**MERCERSBURG ACADEMY**  
**HEALTH CENTER PRE-BID CLARIFICATIONS**

**August 22, 2017**

**RESPONSE ISSUED 8/28/17**

**HALE FEILD HOUSE & HEALTH CENTER  
 MECHANICAL PIPING SKETCH  
 DRAWING NOT TO SCALE**

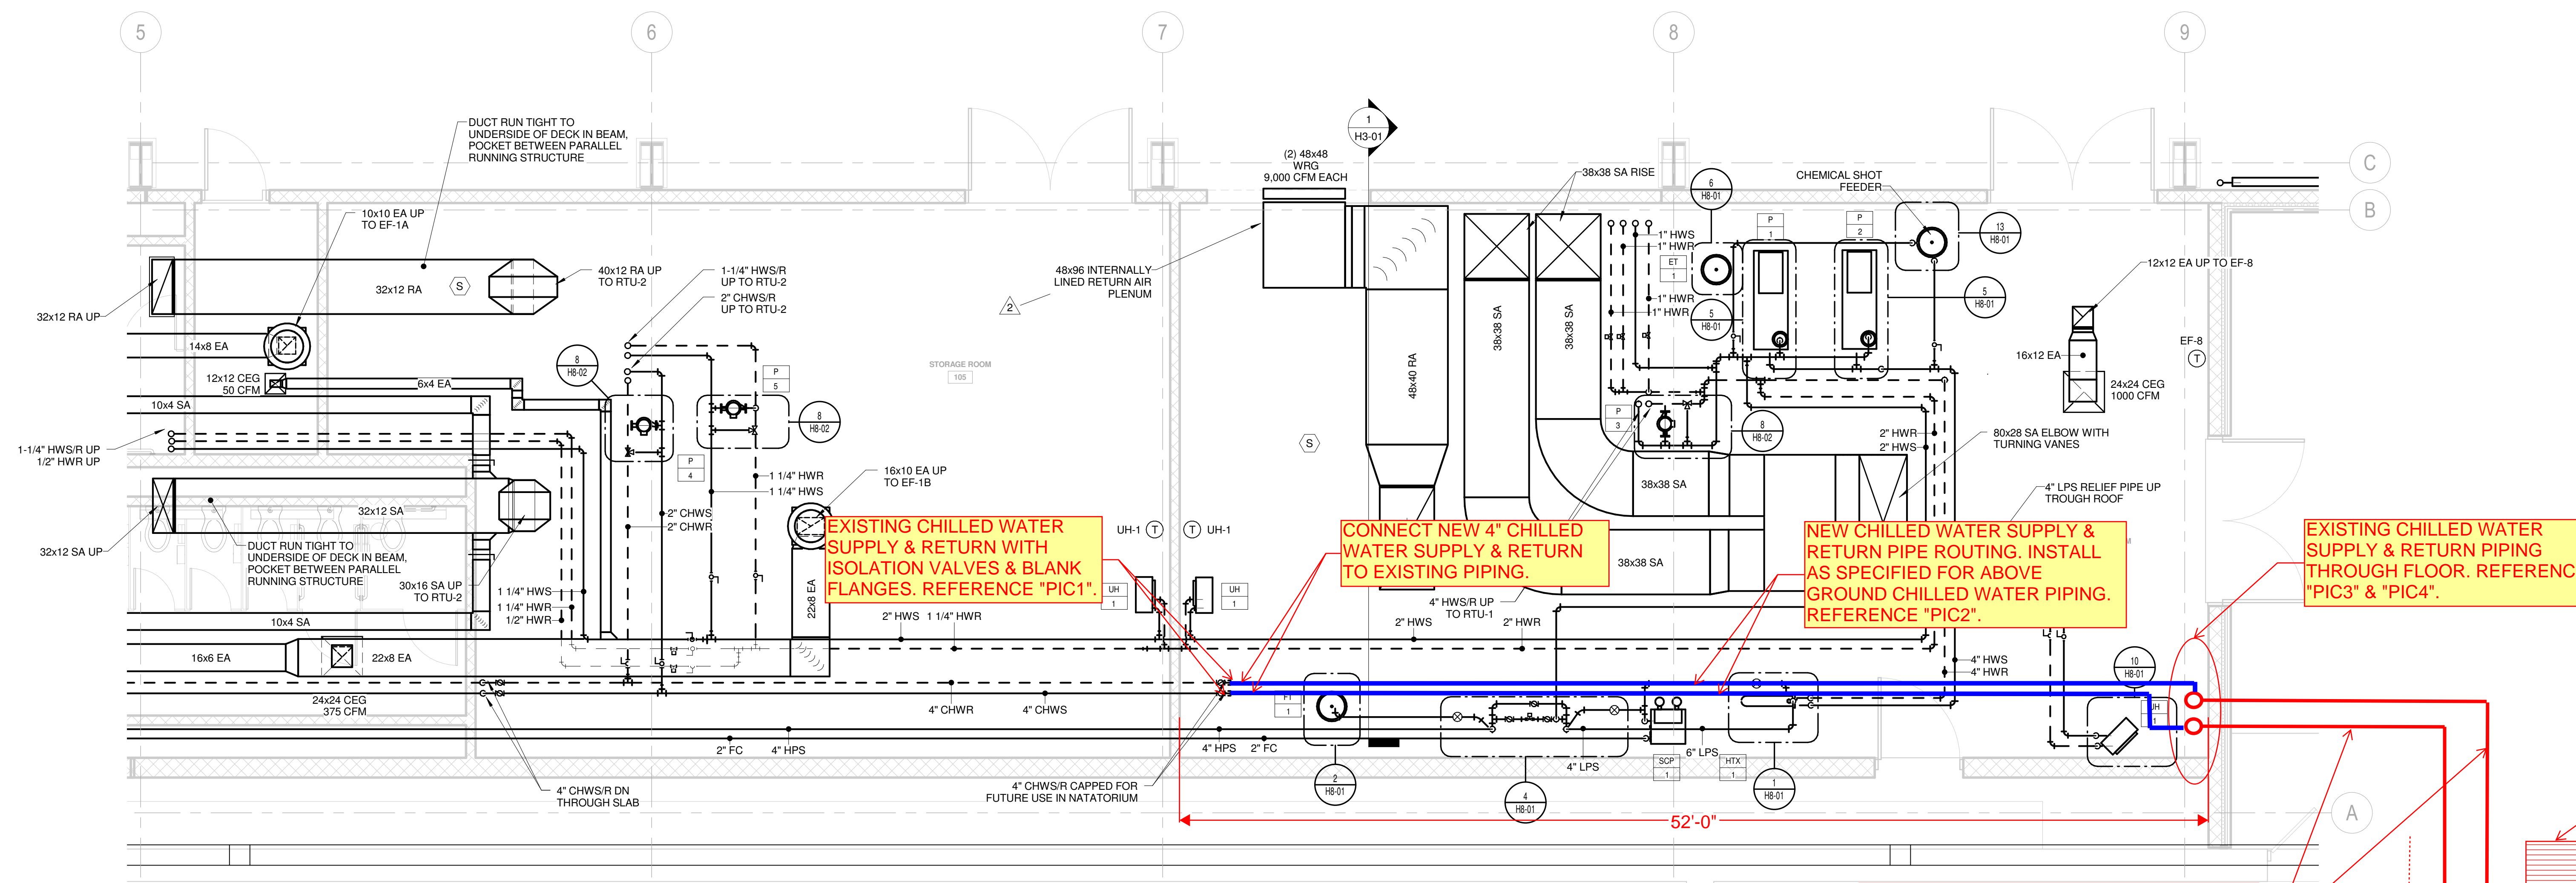
1. The chilled water piping located in the rear of the Hale Field House are not connected internally to the existing chilled water system. Should we cover this in the Health Center Renovation scope of work?

**Yes. Please connect both ends of the chilled water piping located in the mechanical room of the Hale Field House. Lineal feet of piping is about 50-55 feet. Contractor shall install per above ground chilled water piping and insulation specification. Reference supplemental sketches and pictures sent with this clarification.**
